Review of Reactor Pressure Vessel Evaluation Report for Yankee Rowe Nuclear Power Station (YAEC No. 1735)

Prepared by
R. D. Cheverton, T. L. Dickson, J. G. Merkle, R. K. Nanstad

Oak Ridge National Laboratory

Manuscript Completed: October 1991
Date Published: March 1992

Fig. A.2. YNPS SBLOCA downcomer temperature from YAEC-1735.

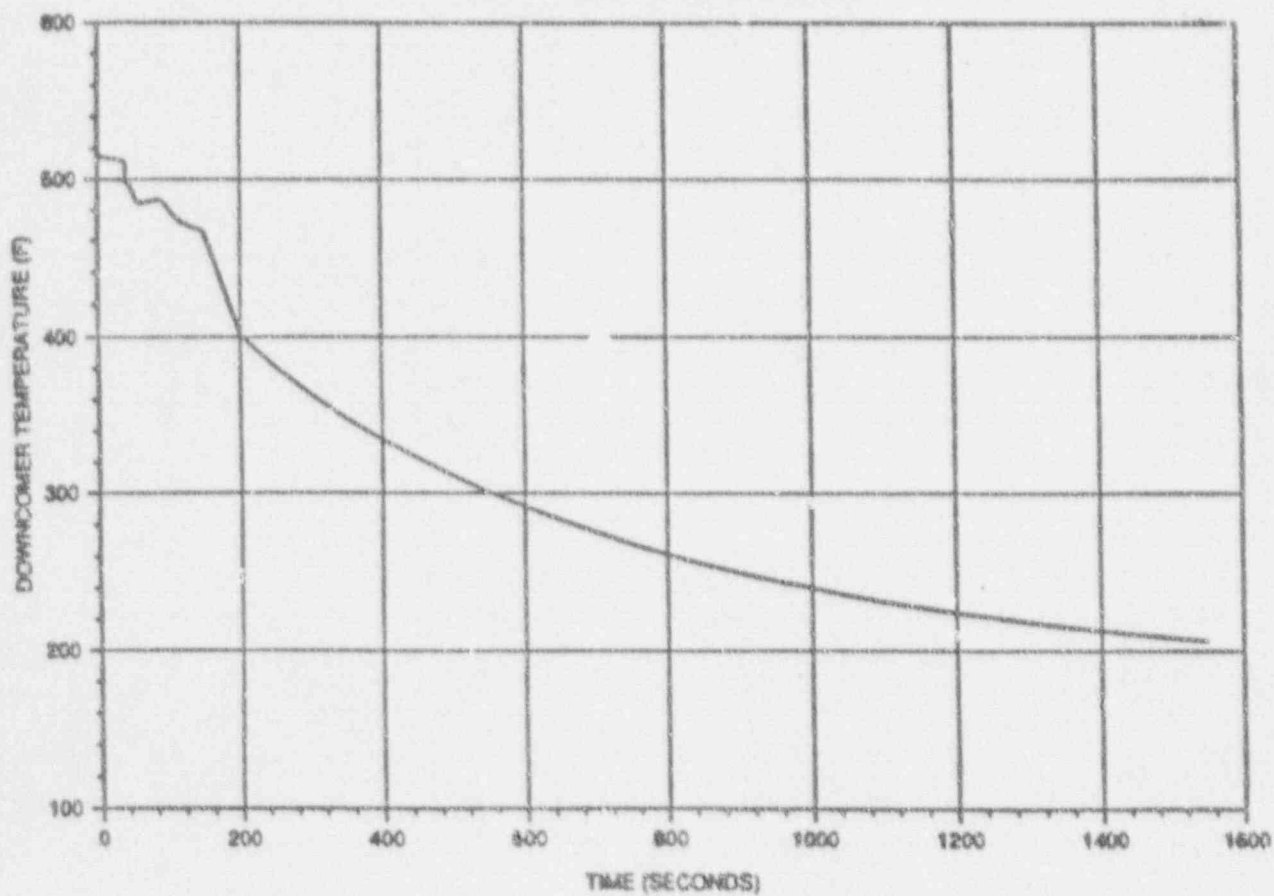
- c) Yankee Atomic Electric Company has employed the REMIX code to determine the transient thermal-hydraulic behavior in the downcomer region. SAIC has developed an independent tool to evaluate the mixed-mean downcomer fluid temperature. Comparison between the two codes show excellent agreement. It is concluded that YAEC has correctly applied REMIX to evaluate the SBLOCA sequence. Hence, the results provided by YAEC should be considered best-estimate values. The mixed-mean fluid temperature of Fig. A.8 should be considered as both best-estimate and as an upper-bound. However, the original downcomer fluid thermal response of YAEC-1735 (Fig. A.2) represents the colder plume region below the cold legs.

Fig. A.8. Comparison between the mixed-mean fluid temperatures in the SBLOCA sequence.

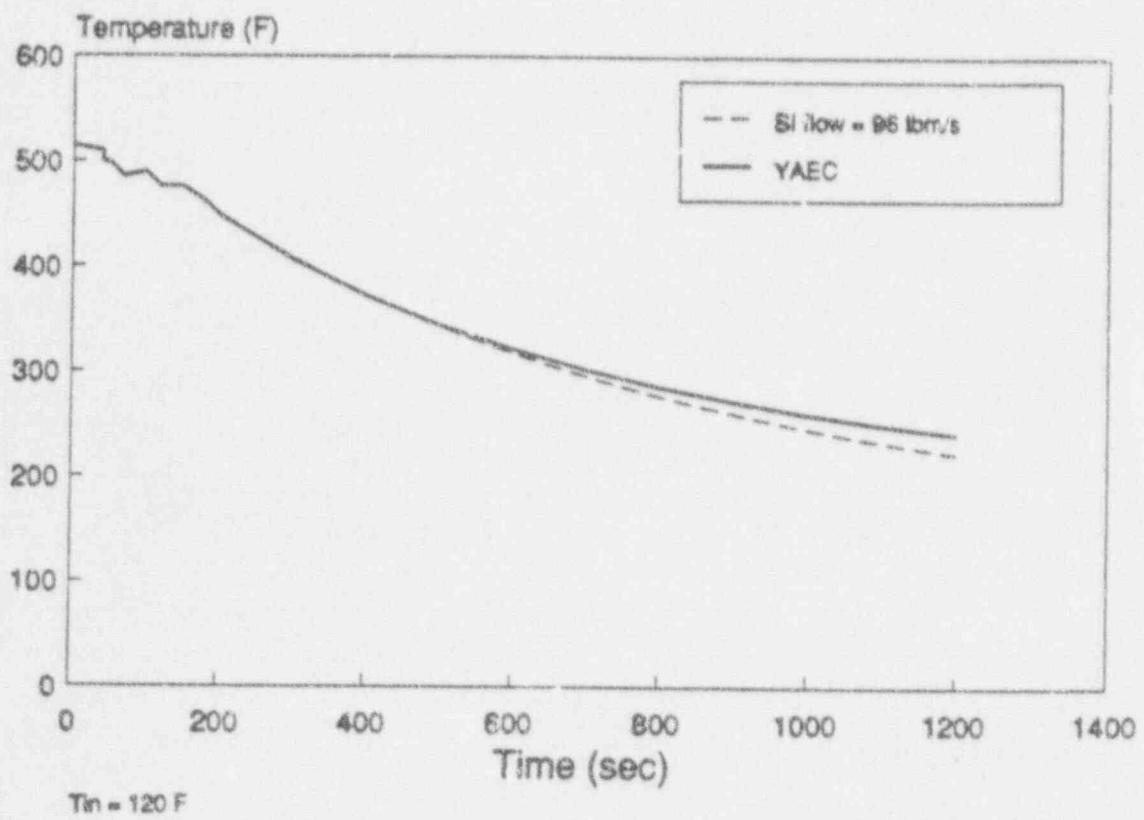
SAIC's new results are compared with the YAEC value in Fig. A.8. Excellent agreement exists between the YAEC REMIX results and the SAIC simplified model. The deviation at 1200 s is less than 20°F and likely occurs due to YAEC's correct inclusion of heat flow from the core region.

Fig. A.10. YNPS pressure vessel vertical cross section.

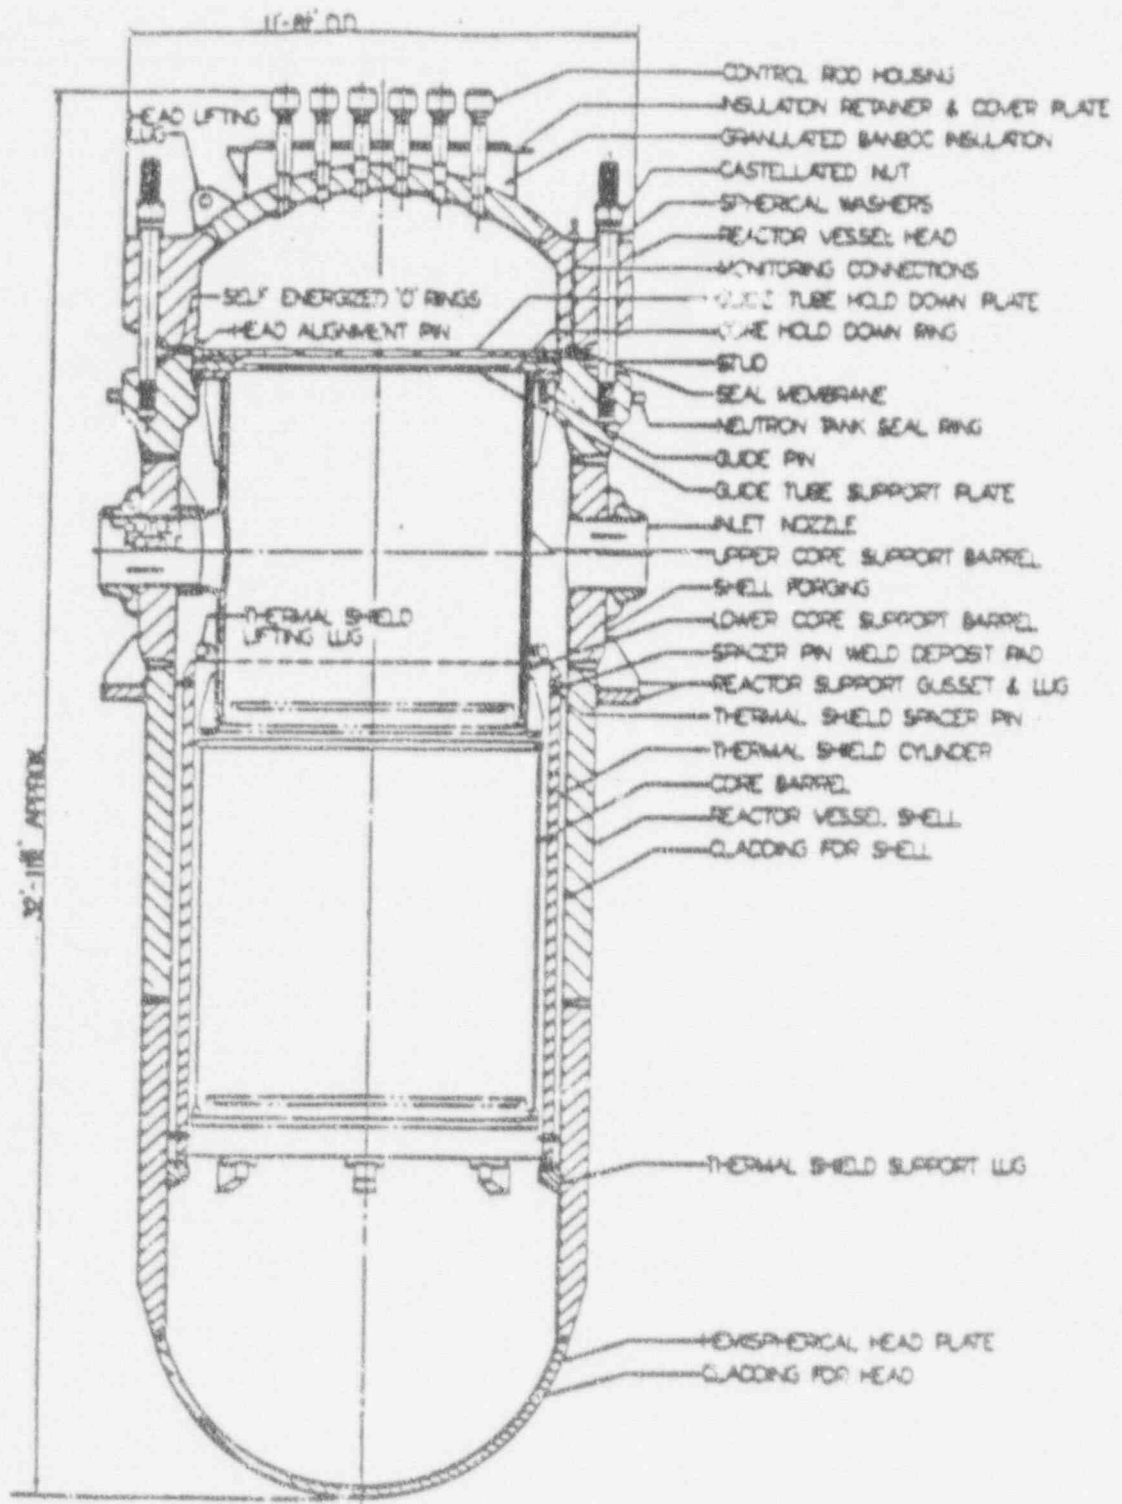
Finally, it is noted that certain Yankee plant-specific design features may serve to influence the fluid-fluid mixing process relative to that expected of larger plants, e.g., Calvert Cliffs. These unique features are revealed by the pressure vessel vertical cross section of Fig. A.10. For the Calvert Cliffs plant, the downcomer gap is roughly 10 in., while for the Yankee

plant it is about 3 in. This much narrower gap may reduce lower plenum water mixing and influence thermal-hydraulic behavior in the downcomer. Another concern is the influence of the Yankee geometric details in the downcomer inlet annulus region. As shown by Fig. A.10, the upper core support barrel has an outer diameter significantly smaller than the downcomer region. This Yankee feature could also affect the downflow of colder water in the downcomer and the vessel wall cooldown.

- d) The Yankee plant has design features and operational characteristics that are unique. These include a "recessed" upper barrel, a narrow downcomer/thermal shield region, and a large safety injection flow for a "small" plant. The potential impact, if any, on REMIX hydrodynamic and phenomenological modeling and assumptions should be addressed. However, the REMIX code has been well assessed and must be considered as representing best-estimate behavior.

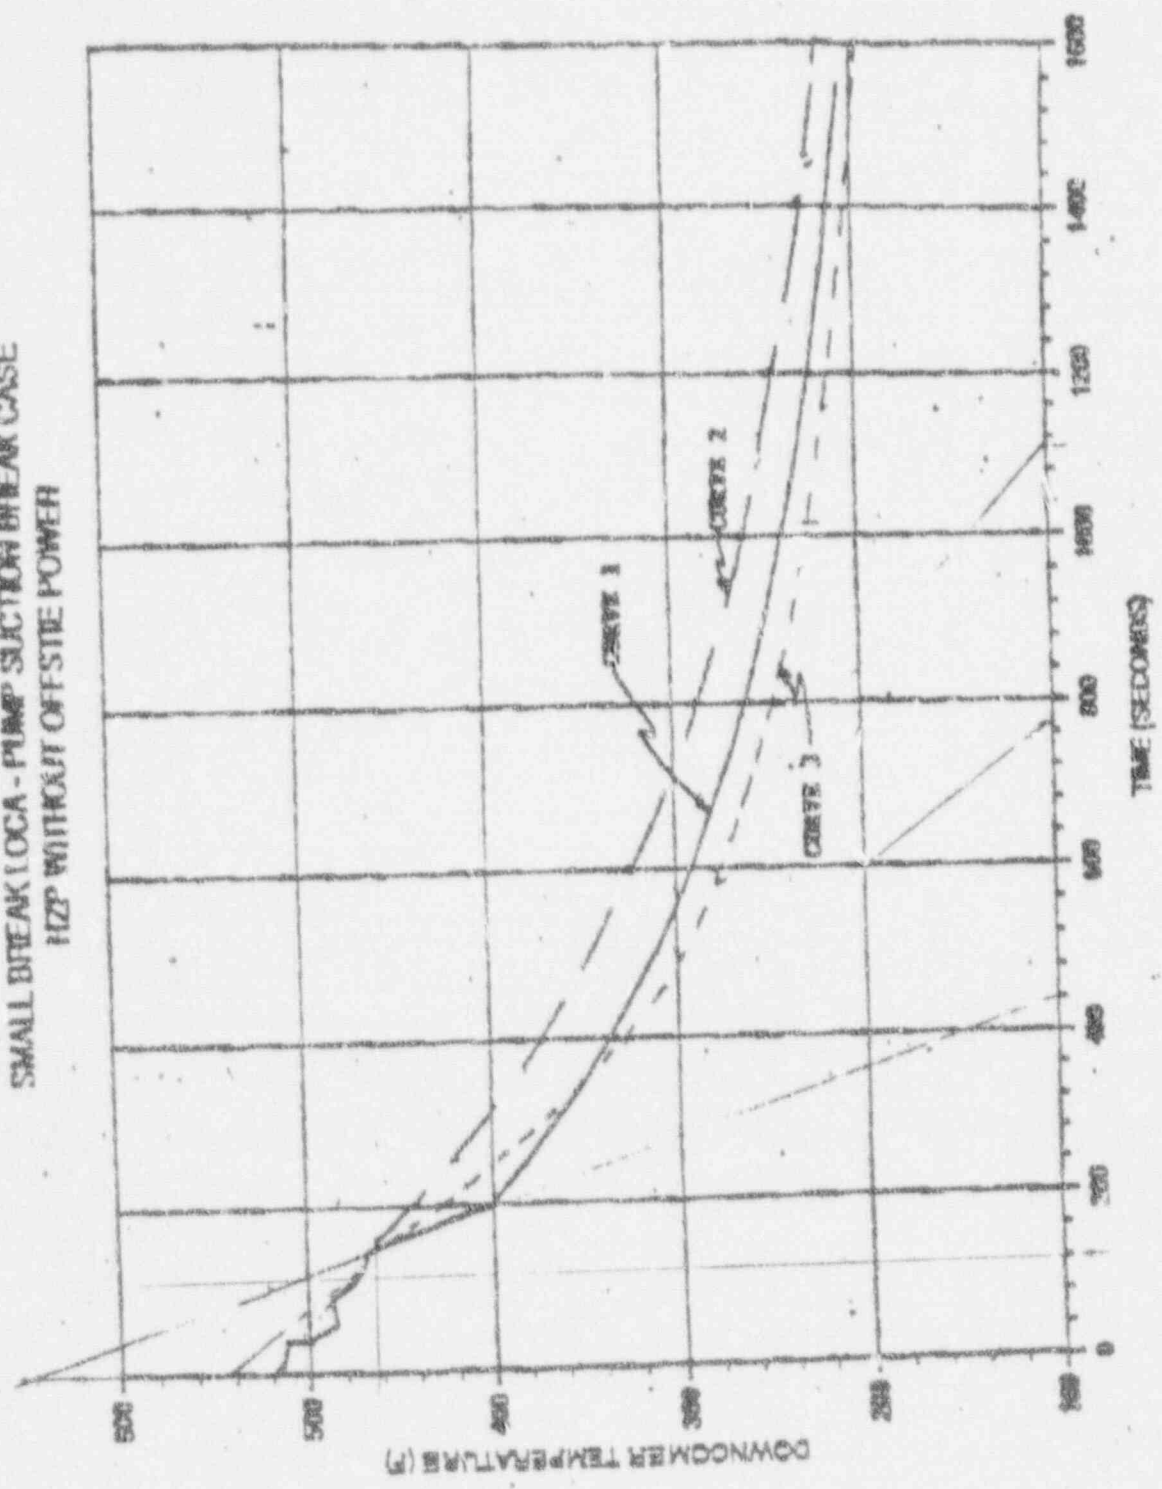
The results reported in our July 1990 submittal for the downcomer temperature were conservatively based on the upper plume temperature predicted from REMIX and not the mixed mean temperature. In response to your recent request (6/20/91) we have evaluated the impact of not crediting the lower plenum mixing volume in the REMIX calculation. The results of our evaluation are presented in the attached figure.

The attached figure provides three curves:

- 1) The original downcomer temperature response for the limiting small break LOCA based on the upper plume temperature near the cold leg nozzle.
- 2) The downcomer temperature response based on mixed-mean temperature as a result of the thermal-shield and core barrel geometry,
- 3) The downcomer temperature response based on mixed-mean temperature without crediting the lower plenum volume.

The attached figure shows that accounting for the unique geometry of the Yankee thermal-shield and core barrel is equivalent to crediting the lower plenum as a mixing volume. Thus, if we were not to credit the lower plenum as a mixing volume, conservatism included in our July 1990 submittal would offset the impact resulting in a similar downcomer temperature response.

It should also be pointed out that the application of REMIX is conservative, and the assumption of stagnation leads to a conservative vessel temperature response. Based on the higher injection velocities consistent with the Yankee ECCS design, more complete mixing would occur in the cold leg than predicted with REMIX resulting in a warmer plume temperature than reported in our July 1990 submittal.

Because of the unique geometry of the Yankee vessel thermal-shield and core barrel region the lower plenum volume should be included in the mixing volume in the REMIX calculation. Even if the lower plenum was not credited in the REMIX calculation, based on the above stated conservations, the vessel temperature response reported in our July 1990 submittal remains bounding.

Fig. C.8. Comparison of J_{max} values calculated from Eqs. (8) and (13) with the J-R curves from Figs. C.5 and C.7.

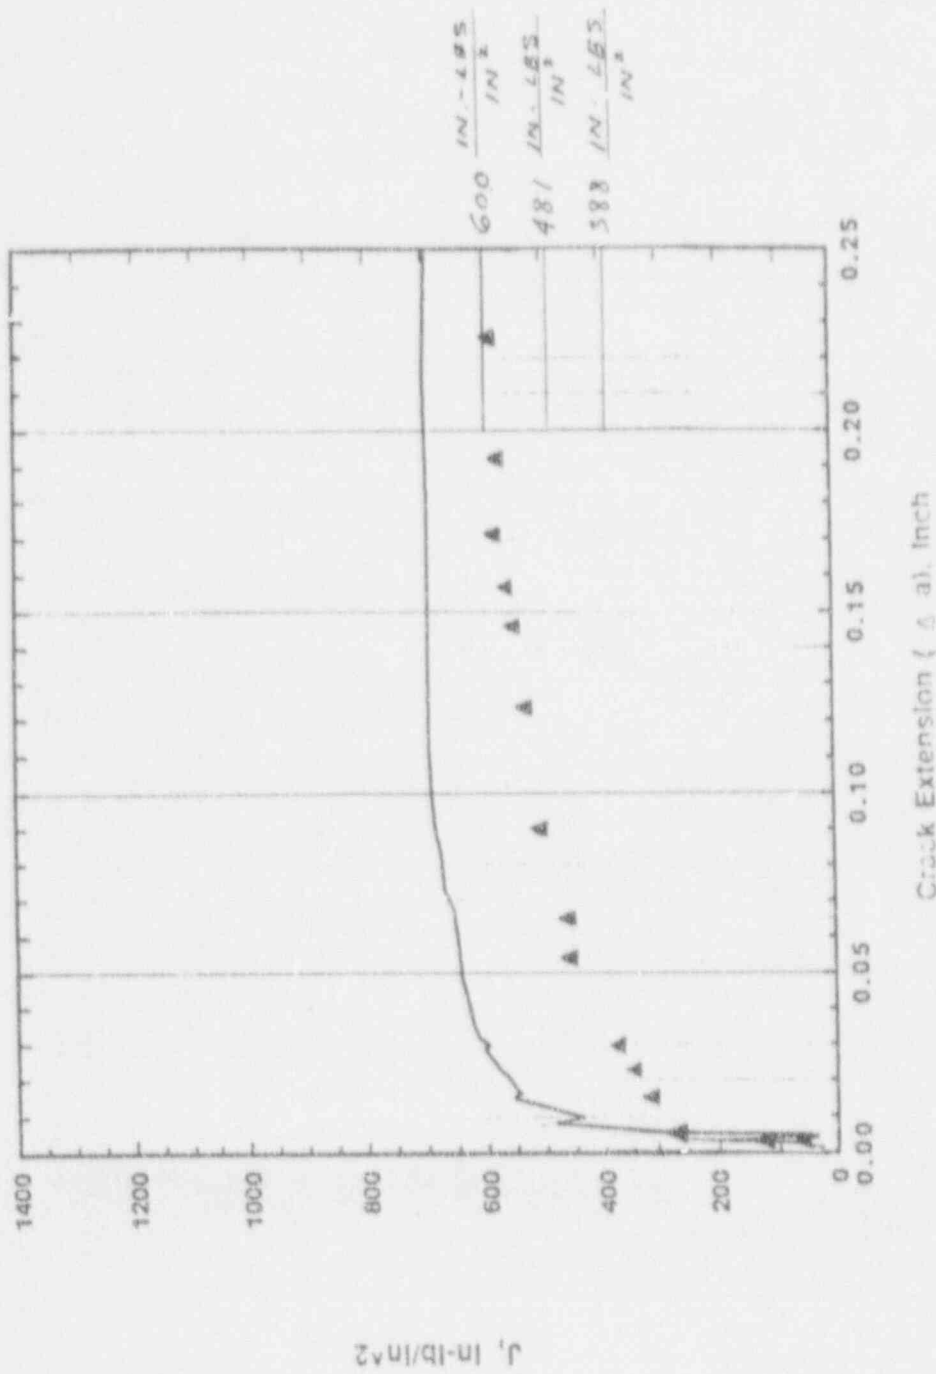
Figure C.8 shows the J-R curve for irradiated Linde 80 weld specimen W8A-121 from Fig. C.7 compared to the J-R curve for the unirradiated 6T A 302 grade B specimen from Fig. C.5, plus the J_{max} values from Table C.5 for A 302 grade B plate, based on the NRC 1990 estimates of CVN. From Eq. (15), the value of J_{max} corresponding to $K_{IC} = 200 \text{ ksi}\sqrt{\text{in.}}$ is 1213 in.-lb/in.². Clearly, $K_{IC} = 200 \text{ ksi}\sqrt{\text{in.}}$ is not an appropriate upper-shelf toughness value for PTS analysis for the near bellline materials in the Yankee Rowe vessel. As indicated in Table C.5, values of 141, 126, and 113 $\text{ksi}\sqrt{\text{in.}}$ are more appropriate for the welds, upper plate, and lower plate, respectively. The sensitivity of P(FIE) to inclusion of lower values is discussed in Sect. D.4.2.

Figure D.5. VISA-II and 1R predicted temperature distributions at time = 10 min. for Yankee Rowe SBLOCA7 thermal transient (R/w = 7).

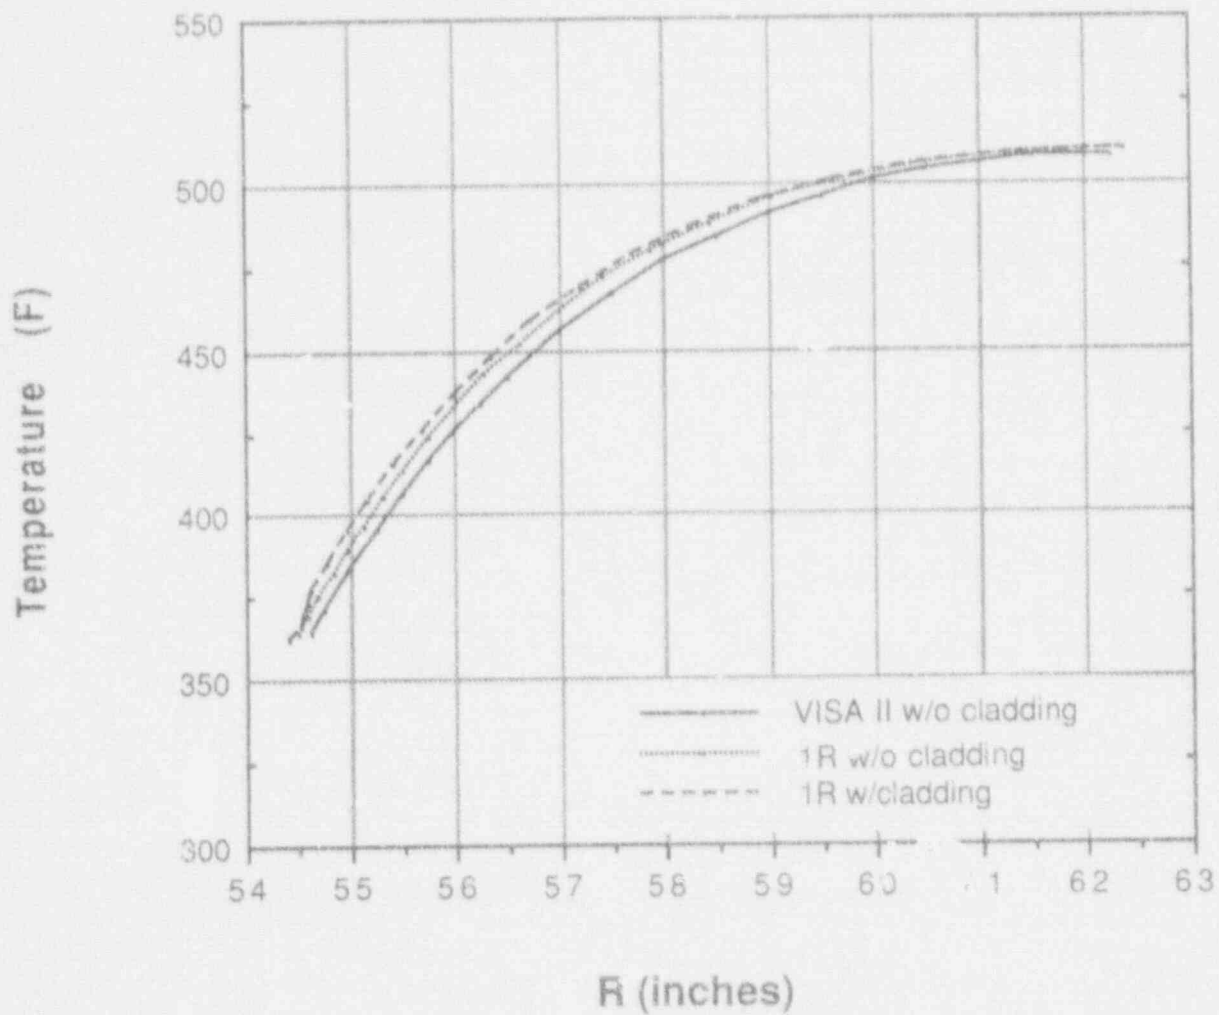
The thermal-response solutions predicted by VISA-II and 1R (the finite-element thermal code used in conjunction with OCA-P) are illustrated in Fig. D.5. As indicated, the VISA-II temperatures are a little lower in the base material. This is because the VISA-II analysis did not include the cladding, and because it was based on slab geometry.

Figure D.6. SBLOCA7 pressure transients.

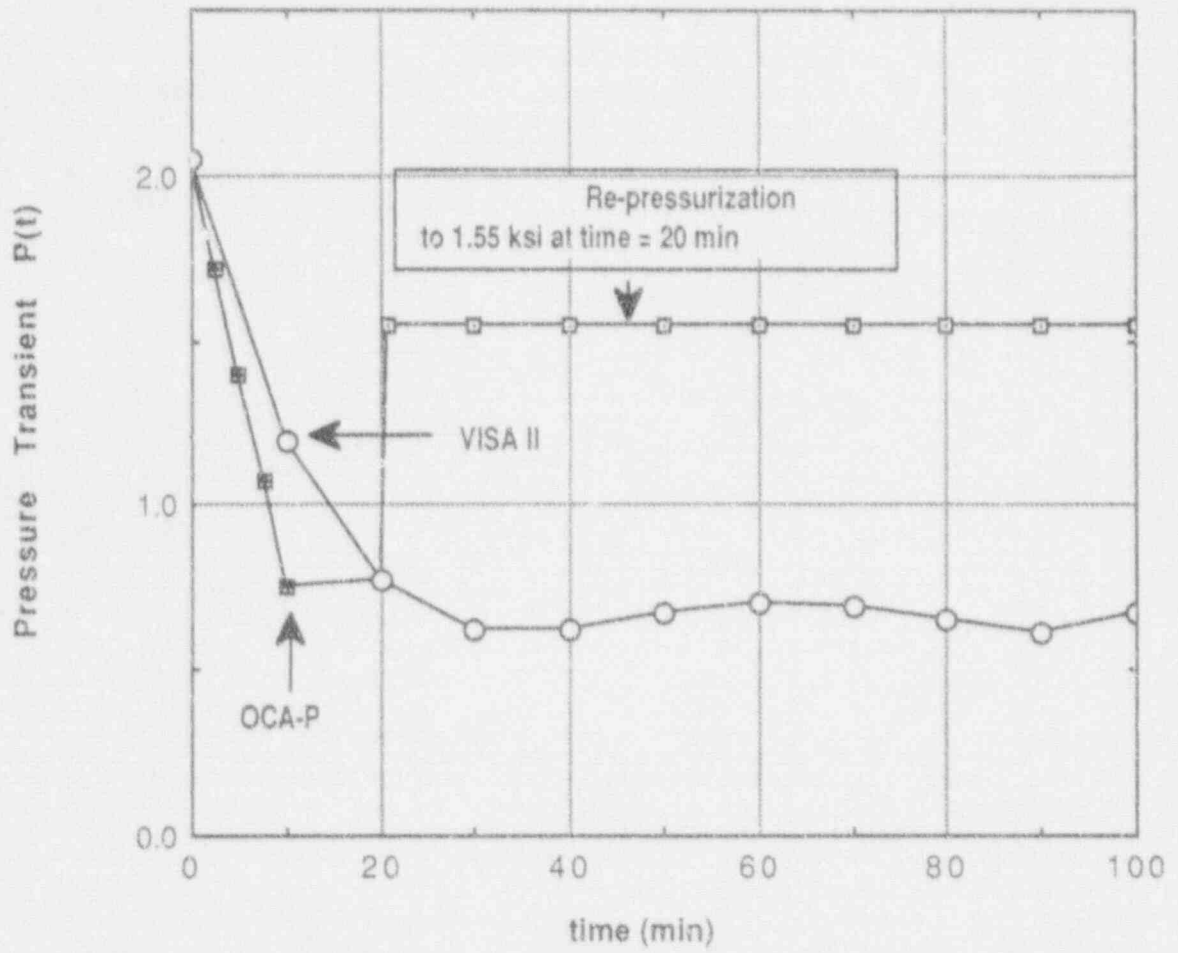
Figure D.6 illustrates the SBLOCA 7 pressure transient. VISA-II uses a polynomial to fit five points in time, whereas OCA-P allows a more accurate point-by-point description of the transient. This accounts for the difference indicated. Also illustrated in Fig. D.6 is the SBLOCA7 transient with repressurization to 1.55 ksi (maximum head of safety injection system)¹¹ at an assumed time of 20 min.
